Re: Response to Request for Additional Information – License Amendment to Reflect Completion of Reclamation, Source Material License SUA-648, Docket 40-0299, Umetco Gas Hills, Wyoming, Site (TAC J00531)

Response to NRC Request for Additional Information
License Amendment to Reflect Completion of Reclamation
Source Material License SUA-648, Docket 40-0299
Umetco Gas Hills, Wyoming Site

Gas Hills, Wyoming
North and South Evaporation Ponds
Remaining Clay Removal Photographs

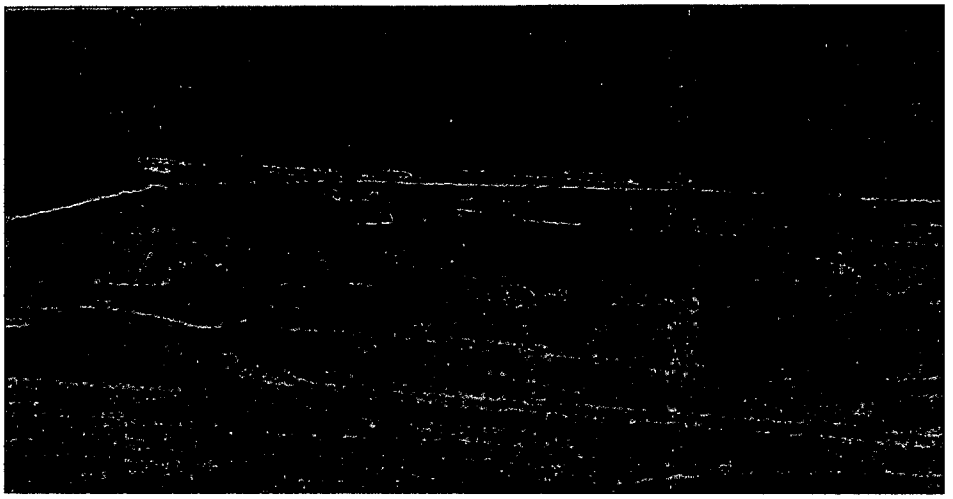
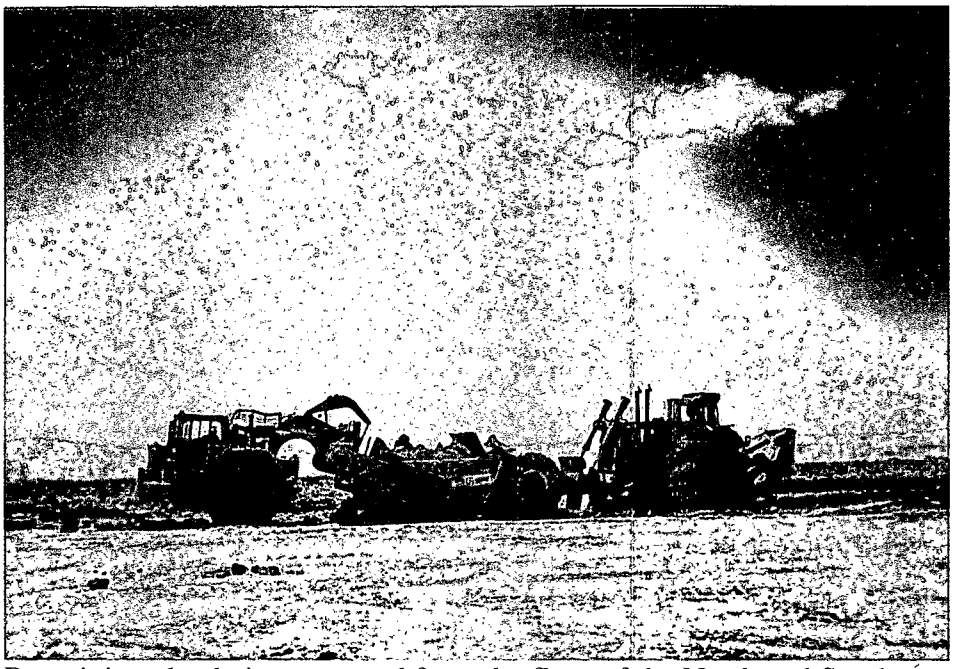
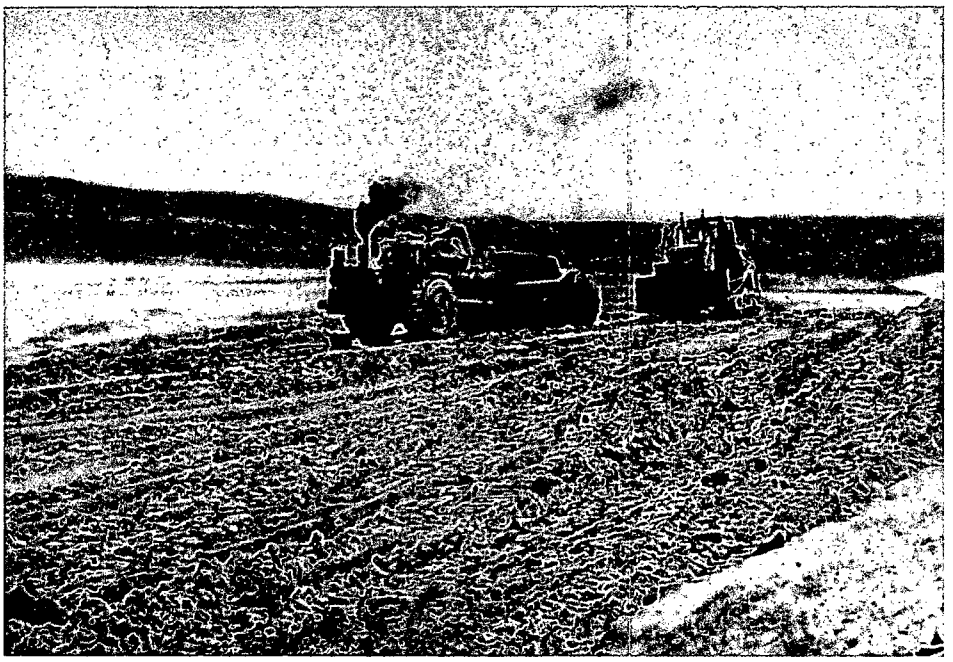
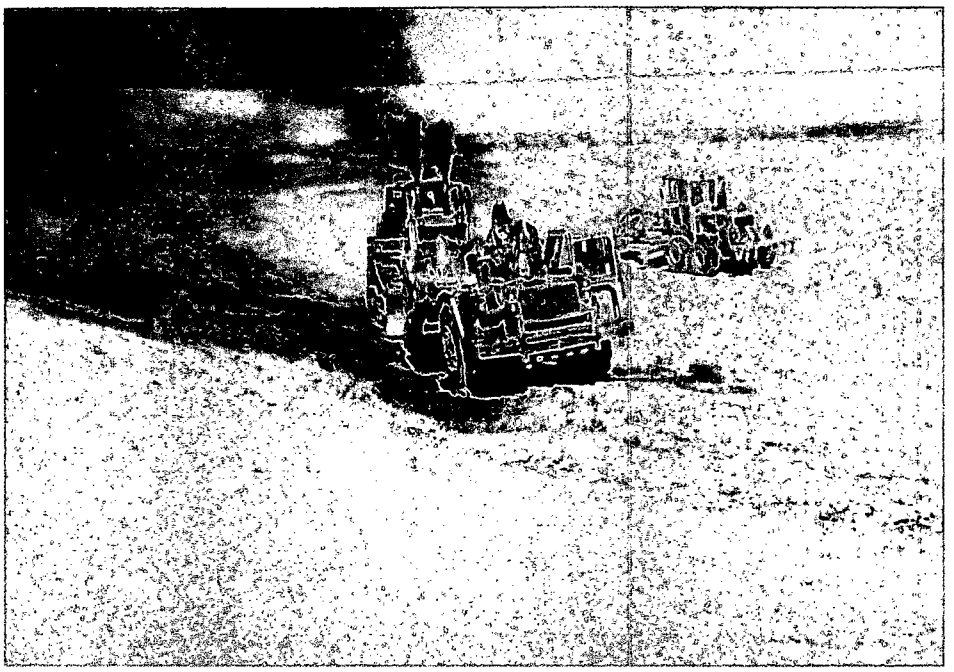
Comment No. 2A. *Please provide a description or reference to the quality assurance procedures used for ensuring that the remaining clay pond liner was removed from the North and South Evaporation Ponds.*

Attachment 2 provides survey verification for this work and photo documentation for removal of the clay liner material.

FIGURE 2.1

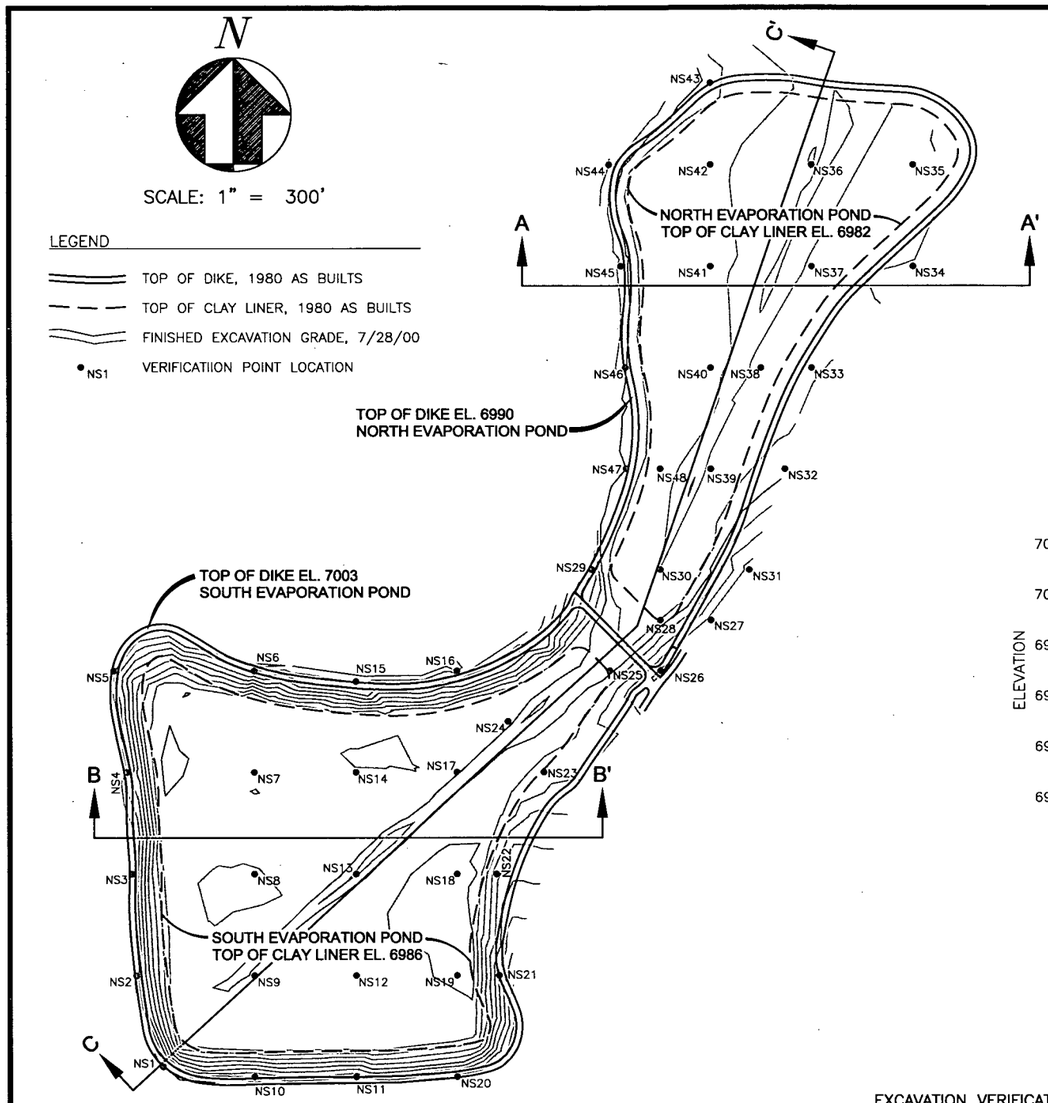
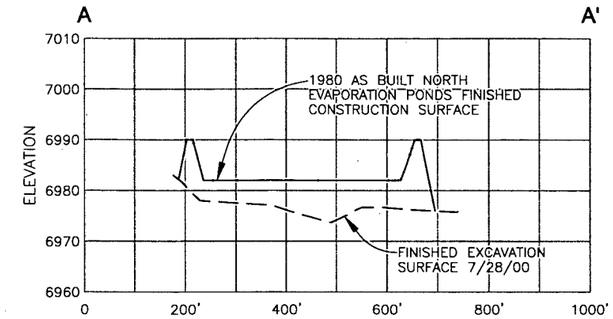
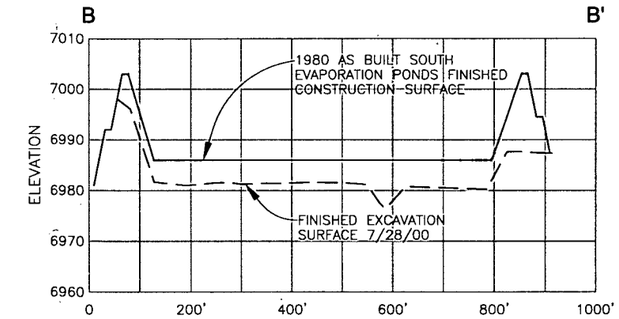
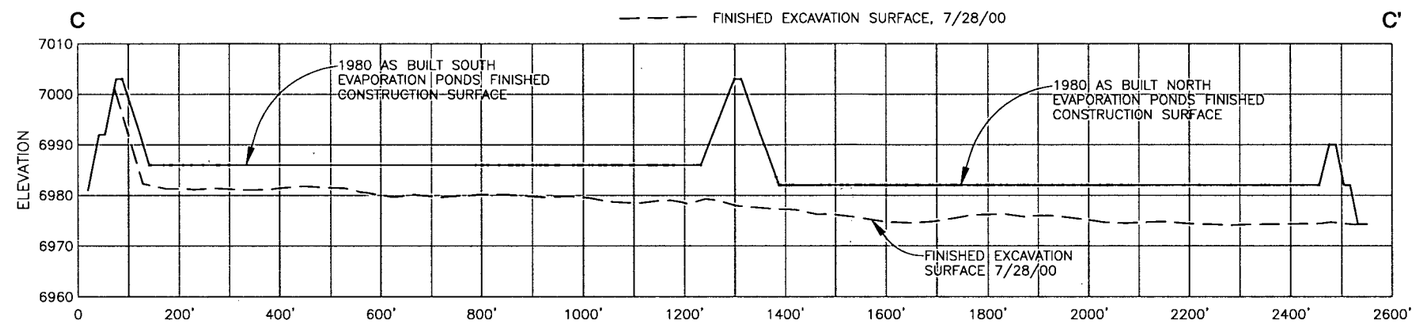
Discussion: *Volume IV of the Completion Report should provide detailed pictures and procedures used to ensure that the clay liner was removed in its entirety.*

Survey verification points were established at 200 foot intervals in the area of the North and South Evaporation Pond Areas on June 23, 2000 prior to excavating the remaining clay liner material (see Figure 2.1). The clay liner was removed from June 26, 2000 to July 26, 2000. The contaminated clayey material was hauled and placed in the contaminated fill area of the A-9 Repository. The fill was placed and compacted as per the approved A-9 Plans and Specifications. The progress of work was continuously monitored and documented. The final excavation in the North and South Evaporation Pond Area was visually inspected to ensure that all of the clayey liner material had been removed. The area was then resurveyed for verification on July 27 and 28, 2000 to verify that the remaining 2 feet of the clayey liner had been removed.
